Recommendation Meeting

501 E Pike St, Seattle WA 98122

A Proposed Apartment Development
for Hunters Capital, LLC.

PROJECT #: 3014780

ADDRESSING EDG REPORT

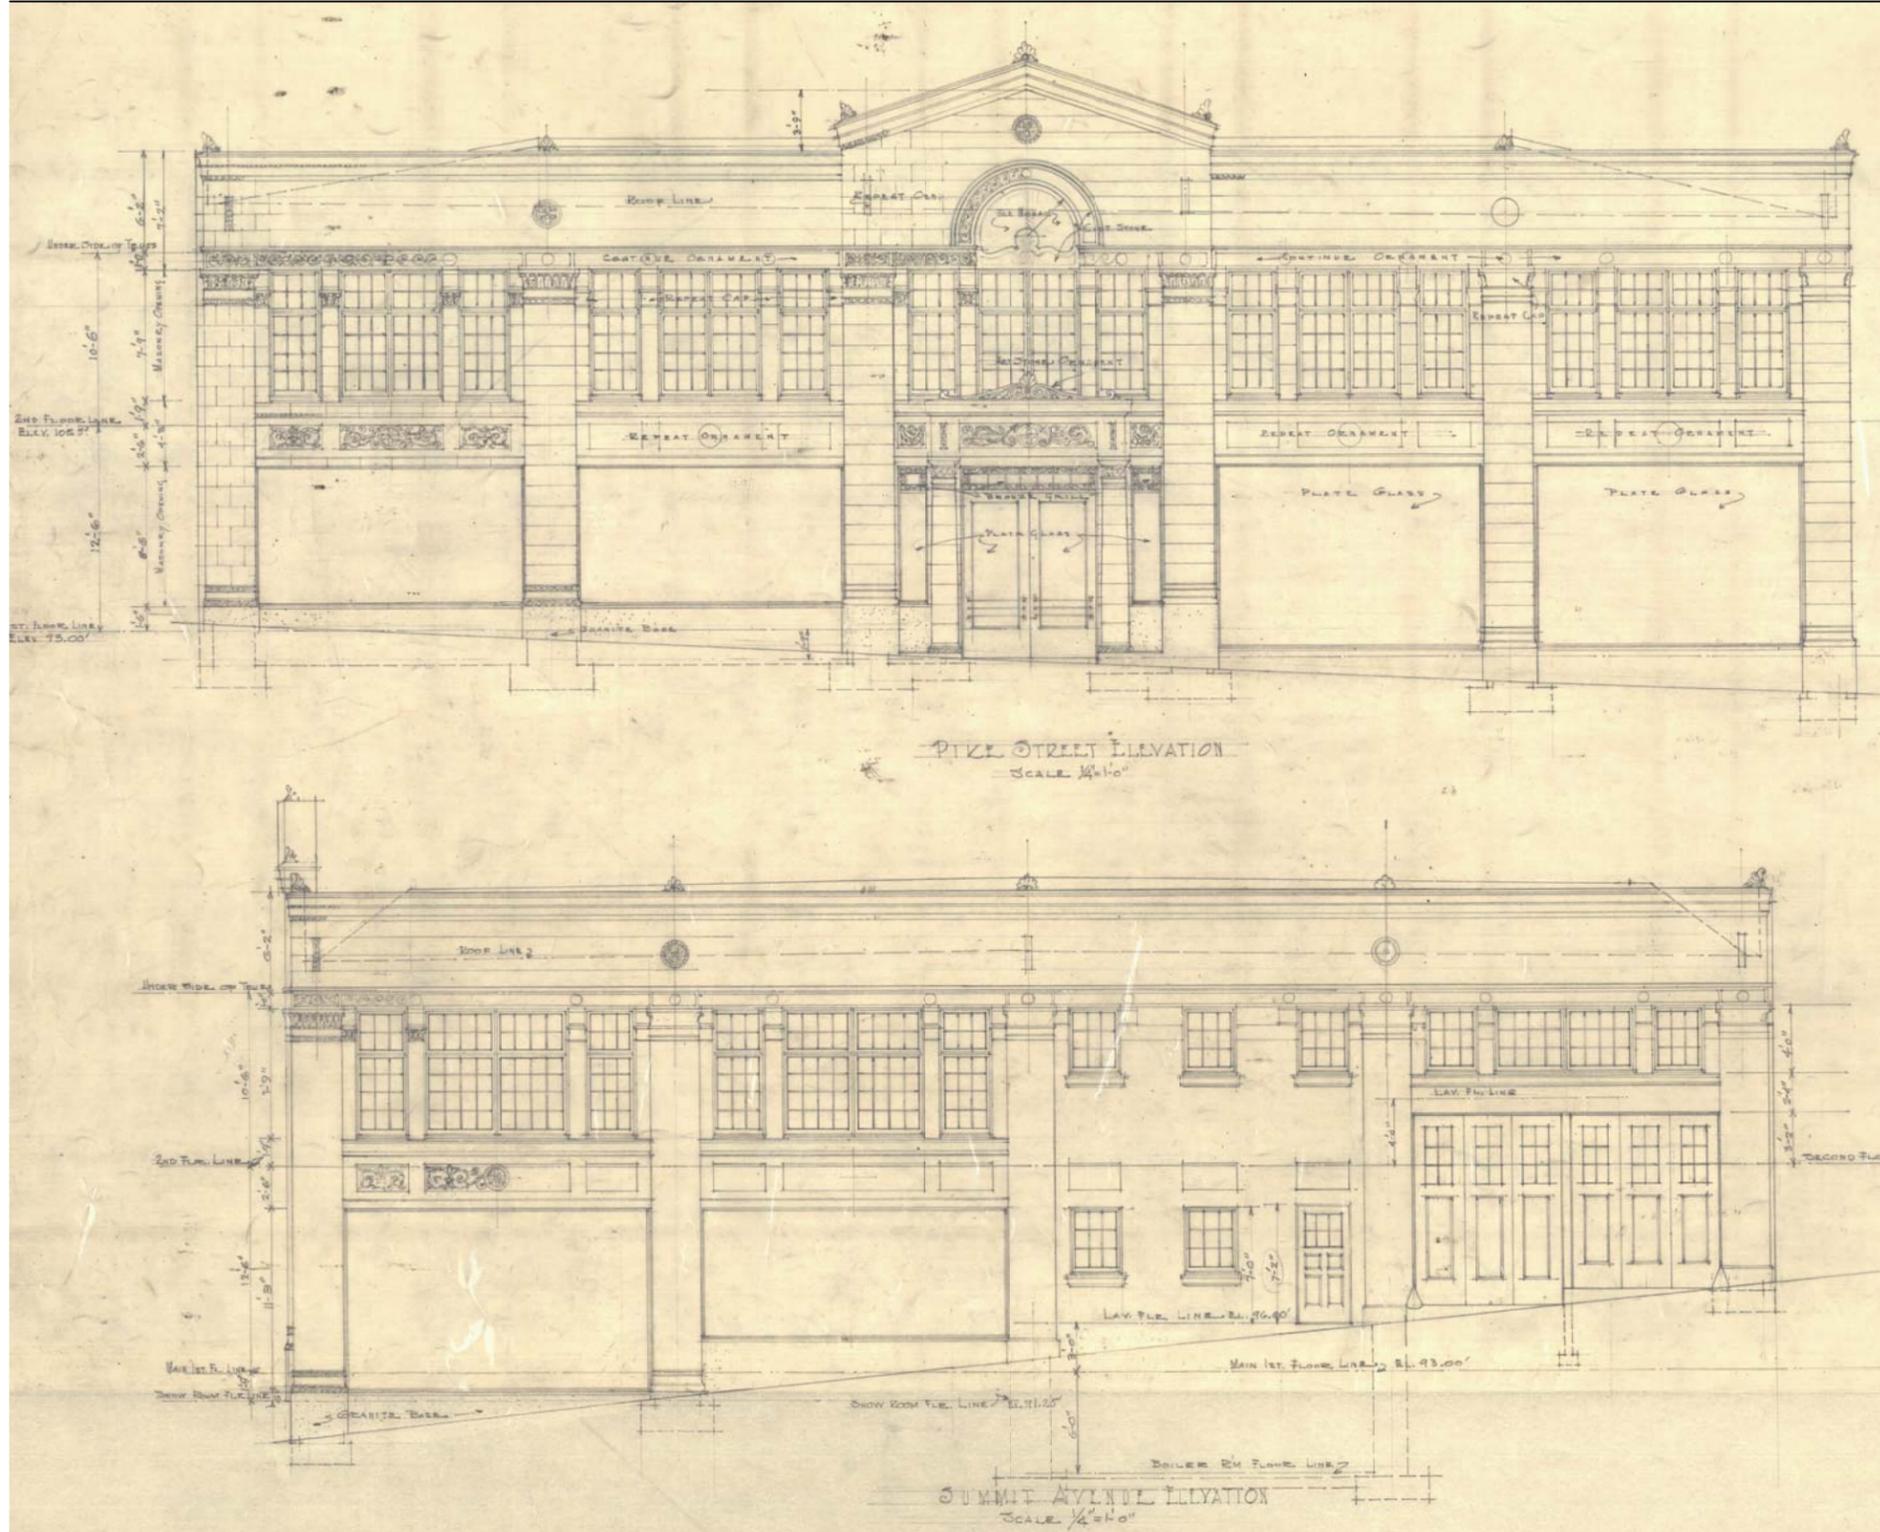
"Expressing concern about the number of students using the sidewalk, the Board members asked DPD to explore the safety issues and report back at the Recommendation meeting. "

See Departures toward end of presentation materials. Also, see attached Traffic Impact Analysis specific to this project.

HISTORIC FACADE

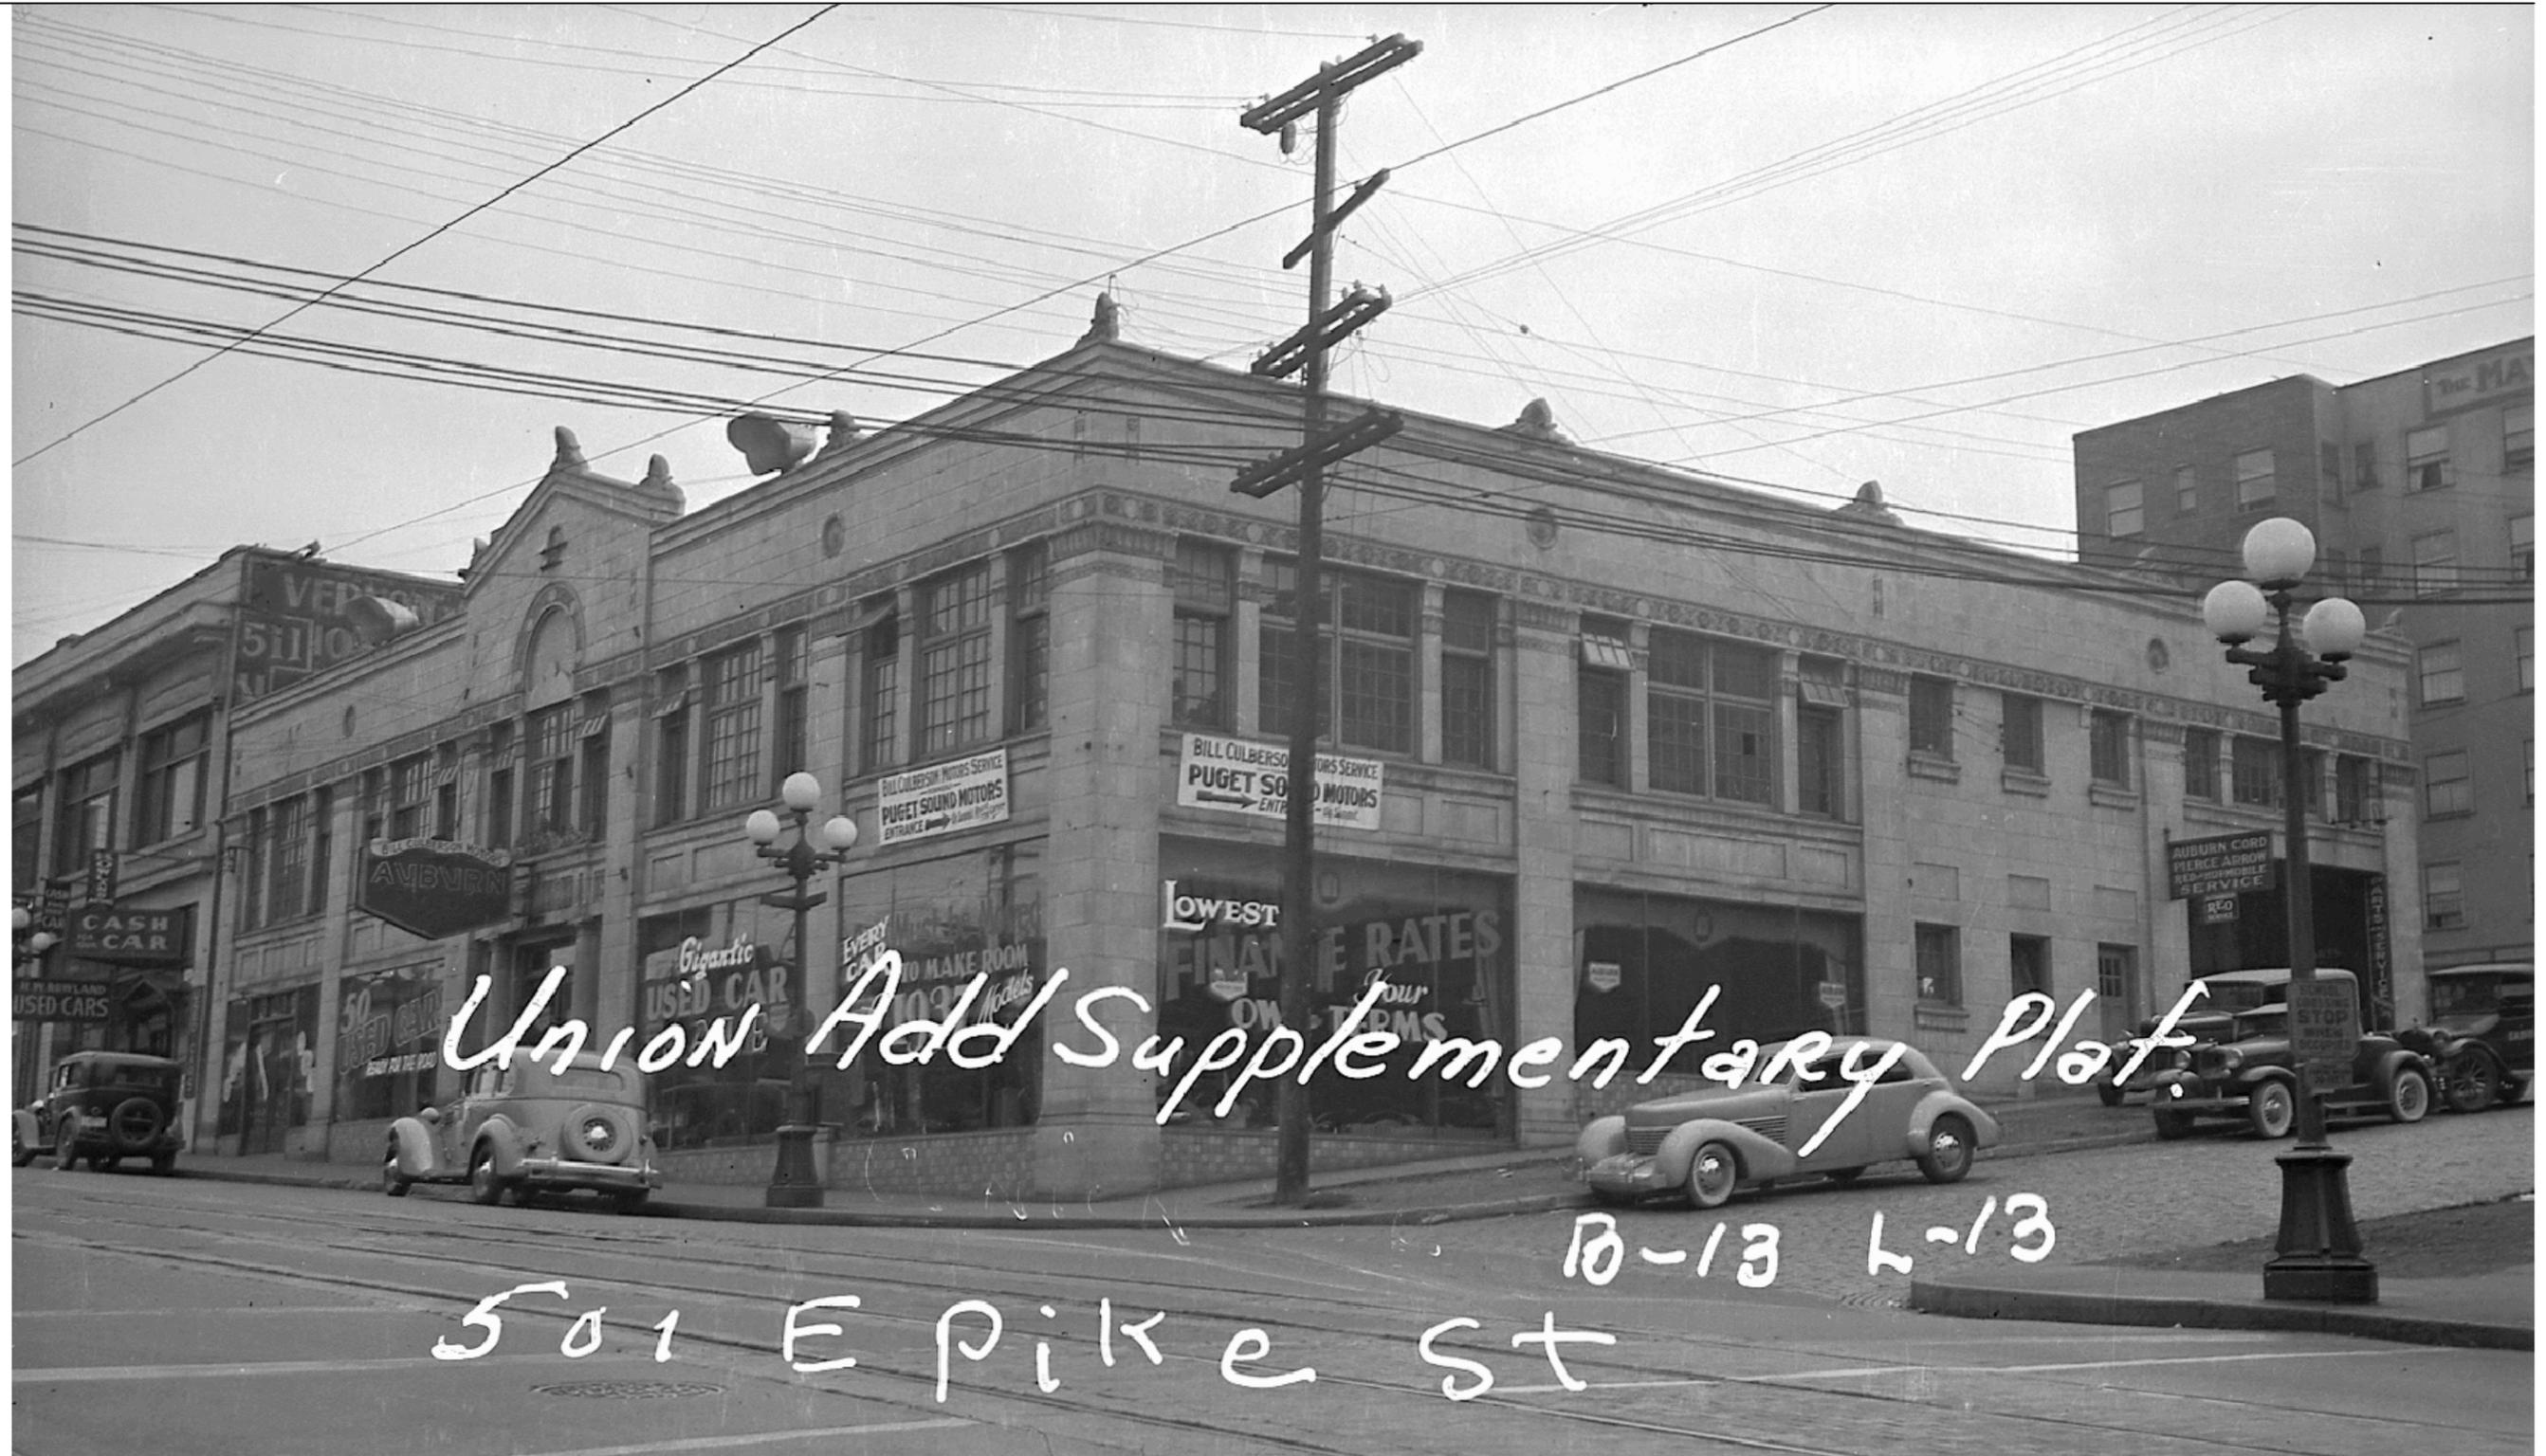
"The Board supports the preservation of the character structure and acknowledged the importance of guideline "c". Provide photos of the original structure for the next meeting."

The board supports the preservation of the character structure. The design maintains the original ground floor and features visible from the exterior (guideline c.). Historic drawings and photo are provided on MUP plan sheet G002 and will be part of the Recommendation Presentation.

DEPARTURE REQUEST

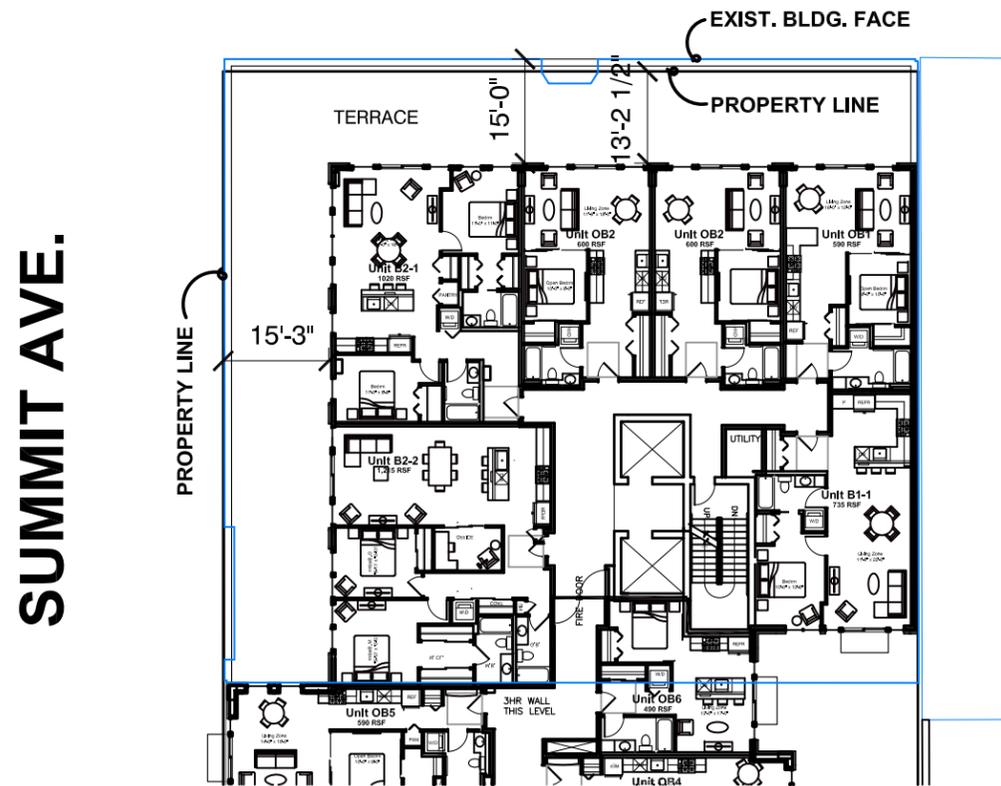
A8- Parking and Vehicle Access:
"The applicant requested a departure to reduce the code compliant driveway width from 20 to 16 feet. See departure discussion at the end of the report. "

"The Board indicated its willingness to review the request. "

#	Code Requirement	Departure Req.	Explanation for Departure
1	SMC 23.54.030.D.1c & D2a2 Minimum Driveway Width for two-way traffic accessing parking area with more than 30 spaces= 20 feet residential, 22' commercial	Reduce driveway requirement to 16 feet.	Guideline A-8, C-1, C-5: The departure approval will allow a design which downplays the garage entry so that it does not dominate the street frontage. The proposal indicates a reduced curb cut and driveway width at the vehicular entrance of 16 feet. The narrow width will encourage slow vehicle entry and exit speeds, thus enhancing other pedestrian safety measures. The width meets anticipated low traffic volumes for the project. The reduced width allows more active/pedestrian oriented uses along the Summit frontage rather than more garage/vehicle related building components.
2	SMC 23.54.030.G.1 Sight Triangle for two-way driveway less than 22'-0" wide, a sight triangle on both sides of the driveway shall be provided.	Allow alternative measures to meet requirements: convex mirrors and signal lights.	Guideline A-8, C-1, C-5: Use of convex mirrors and signal lights, as regularly approved by DPD for use in dense urban sites, will provide a similar standard of pedestrian safety while at the same time minimizing the visual impact of the parking garage entry. The simple shape of the proposed garage entry closely matches the vernacular of the neighborhood. The simplified garage entry will engage the sidewalk without frequently awkward transition spaces common at sloping sidewalks, thus achieving the guideline A-8 and C-5 stated goals. Please see the revised / updated TIA report which addresses pedestrian impacts at the garage access point.
